AGENDA-PLANNING AND ARCHITECTURAL REVIEW BOARD MEETING

SUBJECT: Site Plane and Architectural Review: 7-Brew, 5265 N Port Washington Road, Taxkey Number 1968003000

FROM: Meredith Perks, Vandewalle & Associates, City Planner

MEETING: Planning and Architectural Review Commission August 5th, 2025

CIVIL SITE PLAN

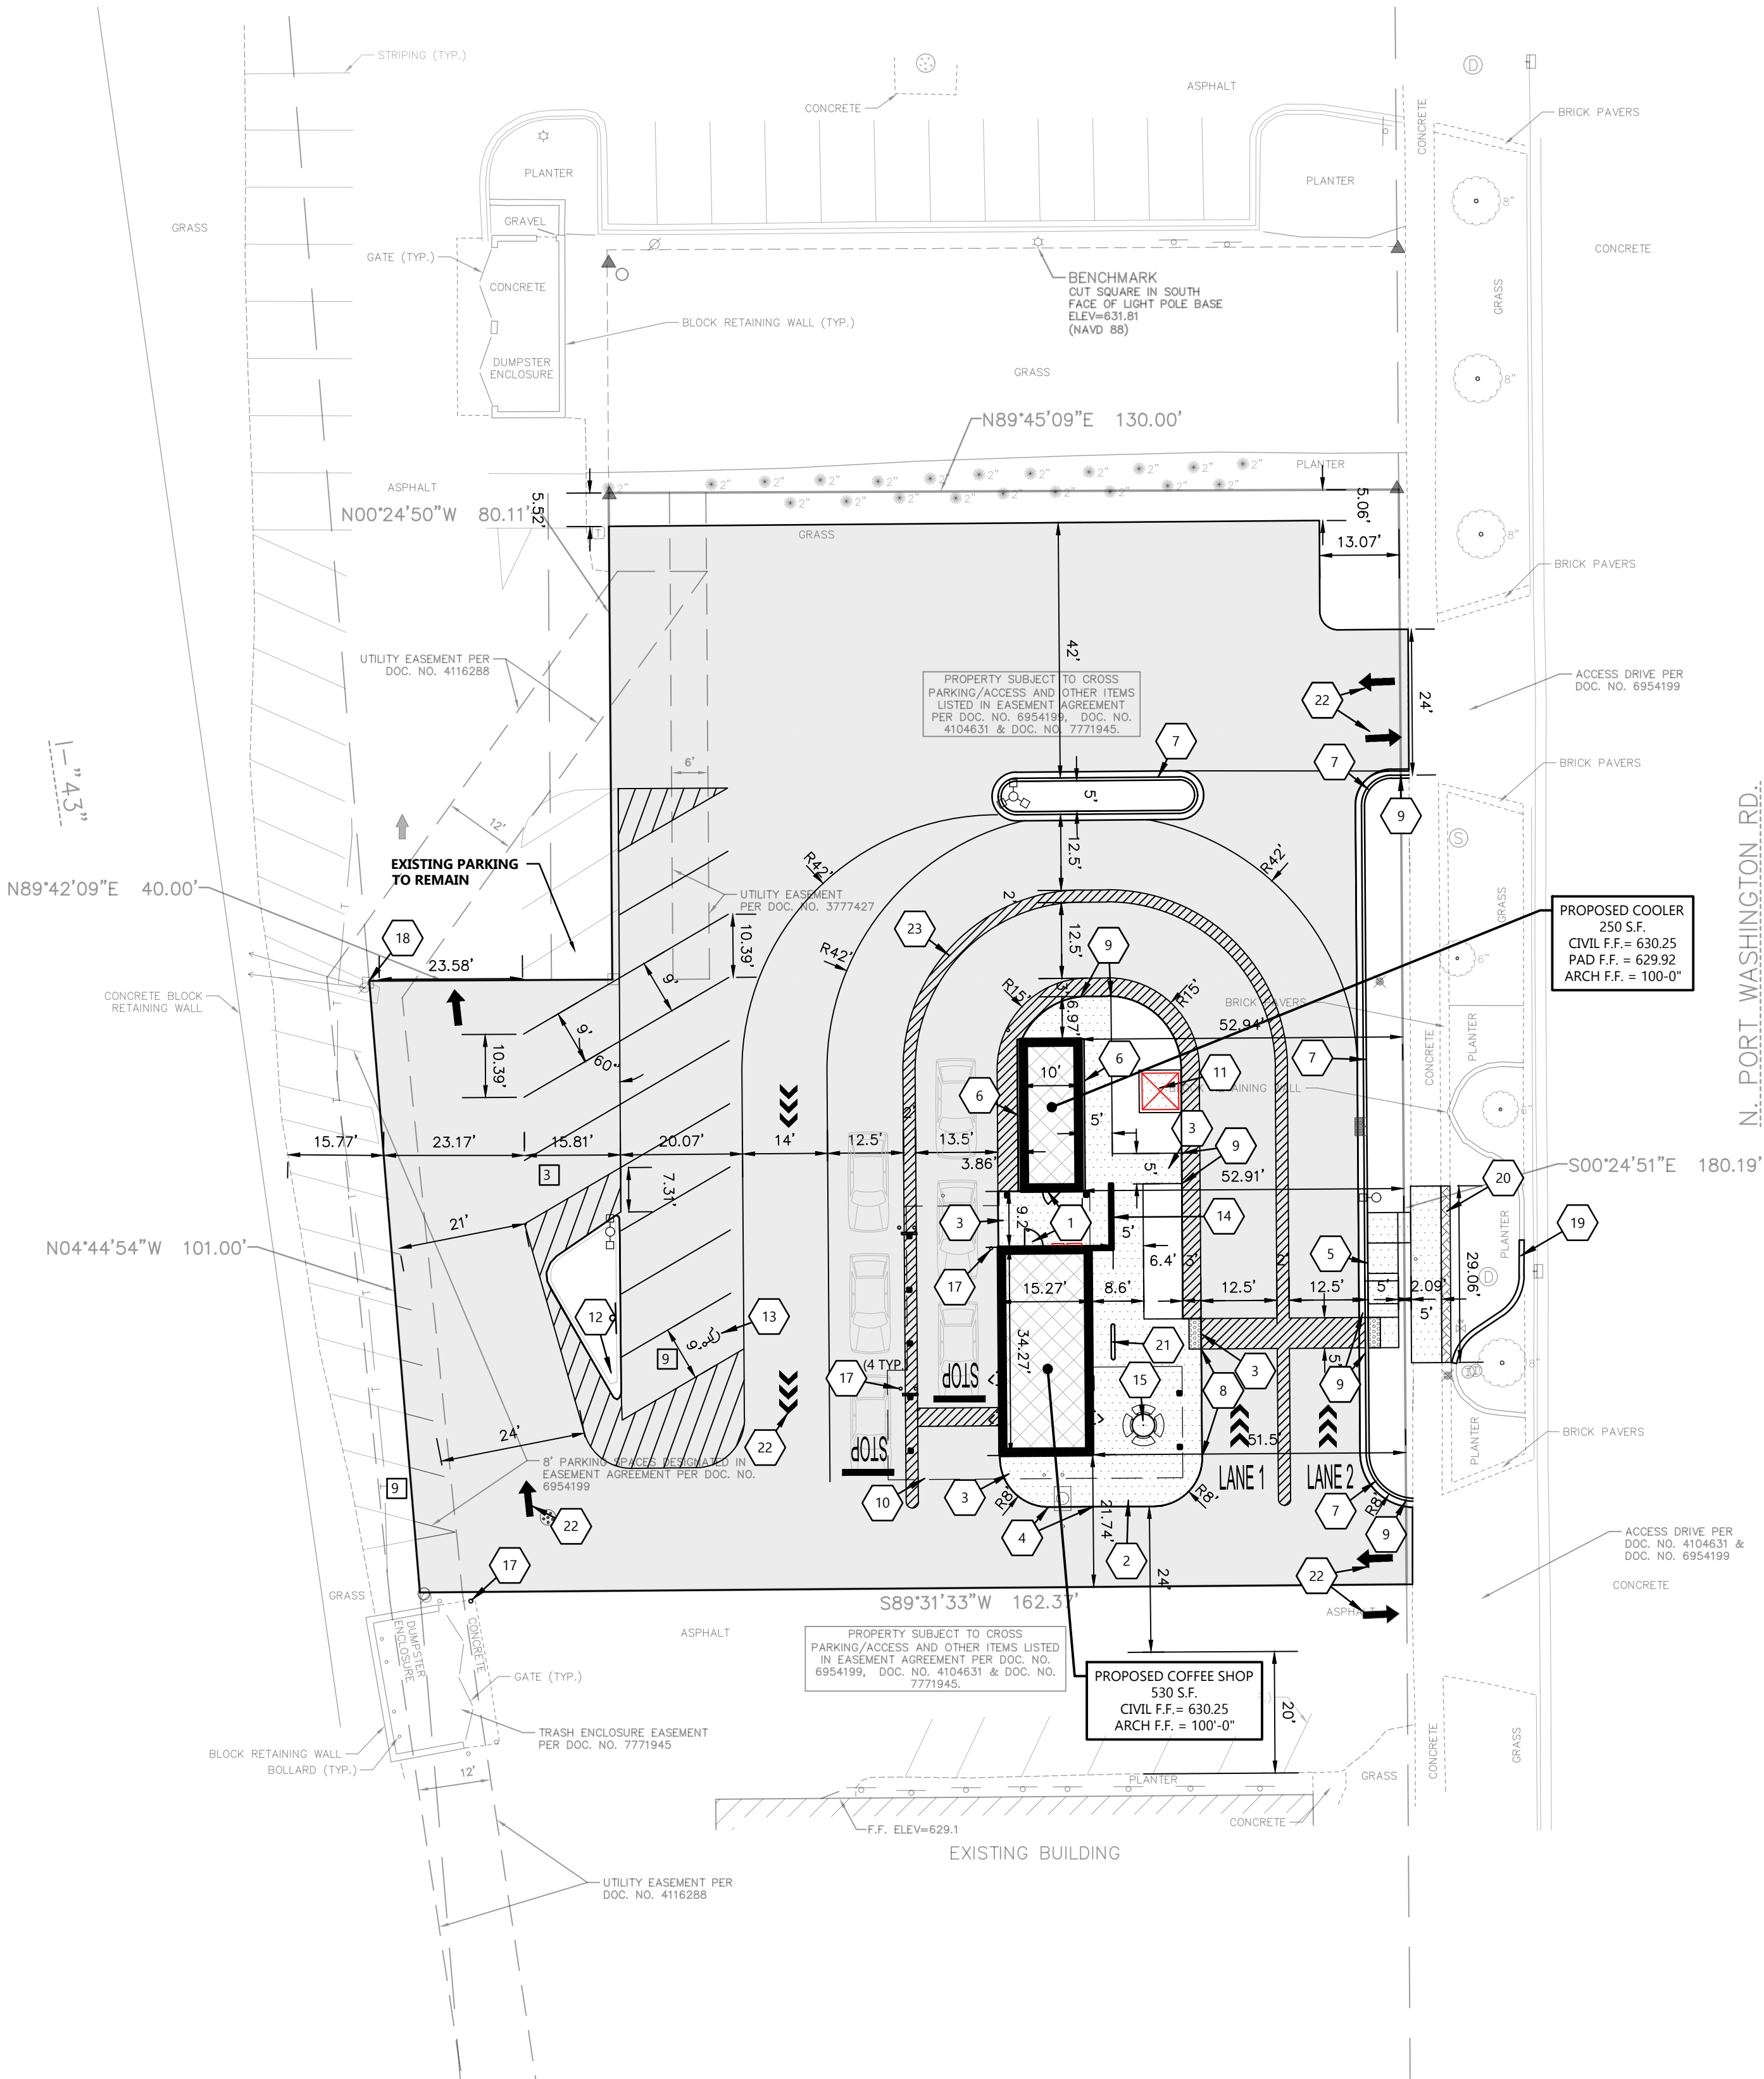
One update to the site plan will be necessary to comply with Code standards; the drive-through lanes 1 and 2 must be marked as starting 25 feet from the driveway on the south end of the property. This can be indicated by painted markers as well as the positioning of employees taking orders.

City Engineering staff have reviewed the site plan and provided comments, including emphasizing that traffic from vehicles exiting the drive-through lanes could experience delays and backup on site while waiting to turn on Port Washington Road. The City will require that if there are any impacts on traffic on North Port Washington Road in the future, the business may be required to make changes to the circulation on site, including but not limited to prohibiting left turns onto North Port Washington Road.

1. Provision of a Sign Permit for approval.
2. Provision of an updated landscape plan addressing staff comments provided in this report.
3. Provision of an updated site plan demonstrating the adjustment of the drive through lane entry markings for 25 feet north of the driveway line.
4. Provision of light fixture and exterior material specifications.
5. Adherence with Engineering and City Services comments.
6. The requirement that if there any impacts on traffic on North Port Washington Road in the future, the business may be required to make changes to the circulation on site, including but not limited to prohibiting left turns onto North Port Washington Road.

CIVIL LANDSCAPE AND RESTORATION PLAN

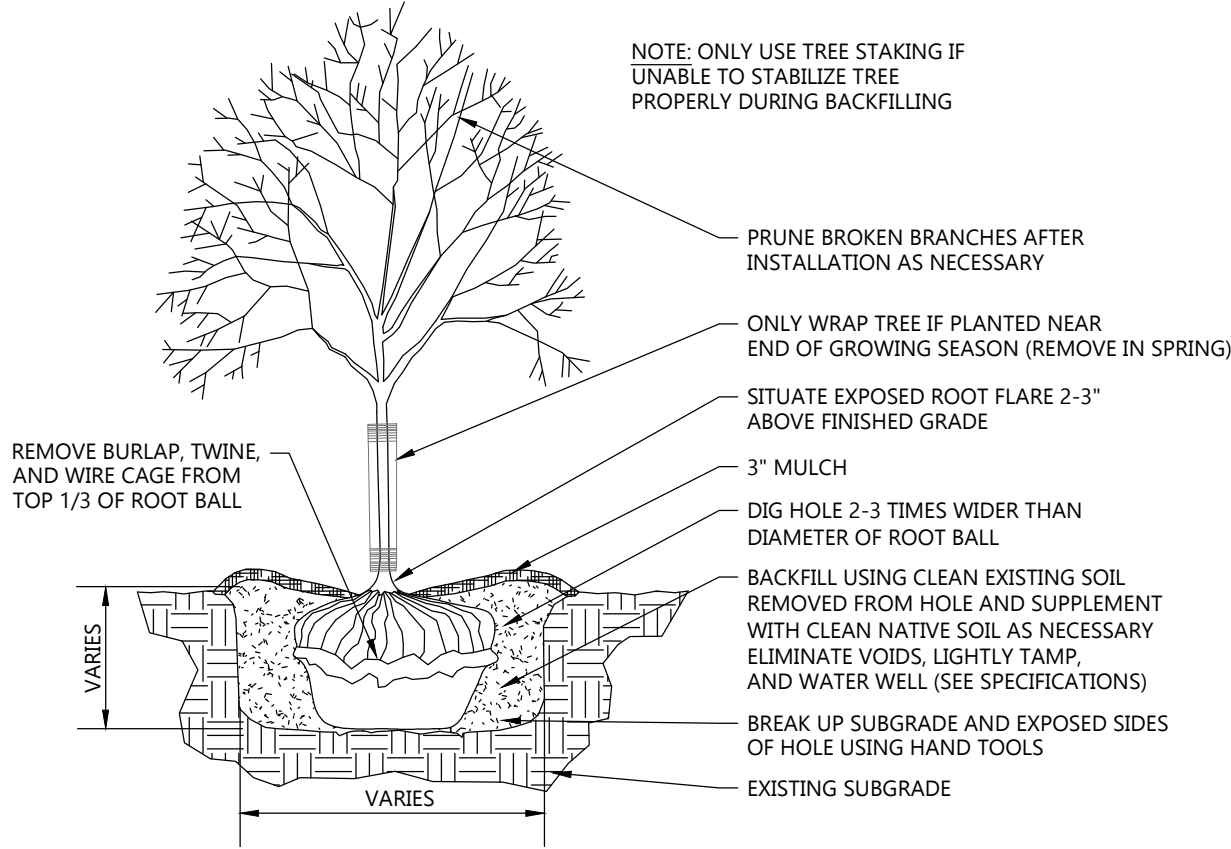
The application included landscaping and photometric plans, as required. The photometric plans meet City standards; however, the applicant will be required to submit lighting fixture specifications for final approval. Staff have provided comments on the landscape plan (see attached comments on the landscape plan) to improve species selection and enhance the landscape design along the parking and street frontages. Recommendations include adding shade trees for safer visibility and the reduction of heat islands. Staff also recommend

incorporating shrubs with taller trees to improve screening and adding interest with variation and color. The applicant must provide an updated landscaping plan addressing these changes for staff approval.
